Upper Ash Pond Dam – A.B. Brown Station Assessment Report

Lockheed Martin
Contractor for the USEPA

September 2009

TYPICAL EMBANKMENT CROSS SECTION

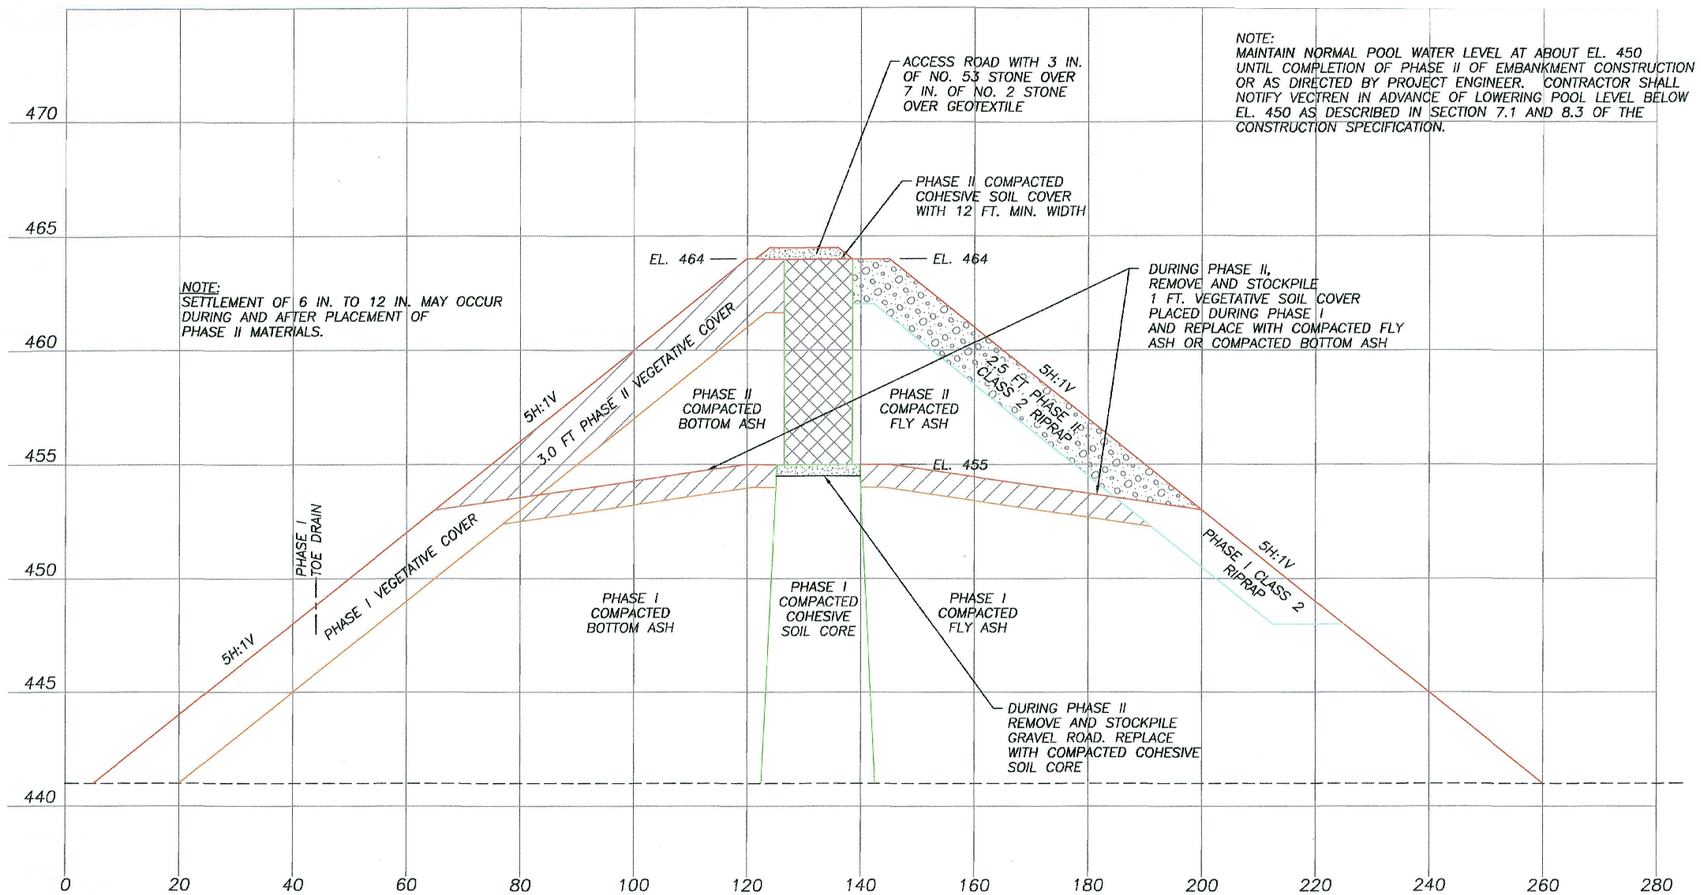
- The Upper Dam embankment design included an upstream zone of compacted fly ash, a central compacted cohesive soil core, and a downstream zone of compacted bottom ash. The embankment was placed over a foundation of uncompacted loose coal ash, with a biaxial geogrid to support the initial lifts of embankment placement. The embankment side slopes are 5H:1V, which is very flat by dam engineering standards and resulted in adequate safety factors for slope stability.

- The 2002 Permit Application recognized that the loose saturated pond ash is susceptible to liquefaction under earthquake conditions and noted that "there is a possibility that the proposed embankment could be significantly damaged due to earthquake-induced liquefaction of the foundation soils." However, it also noted that this condition was acceptable to the owner since a failure of the Upper Dam would not cause any significant downstream damage and due to the low probability of a seismic event during the relatively short estimated life cycle (about 15 years) for the Upper Pond.

The calculated safety factors of 2.46 for the steady state seepage condition, 1.34 for the end-of-construction case, and 1.16 for earthquake loading exceed the typical minimum allowable safety factors for these loading conditions. However, the earthquake loading condition does not account for liquefaction potential, which was discussed in Section 3.2 above.

2. The potential liquefaction issue should be investigated to establish a procedure for monitoring and/or protection against the consequences of foundation liquefaction during a seismic event. The procedure may be as simple as inspection of the earth embankment during or immediately after any measurable earthquake, but some measures should be implemented to address this issue.
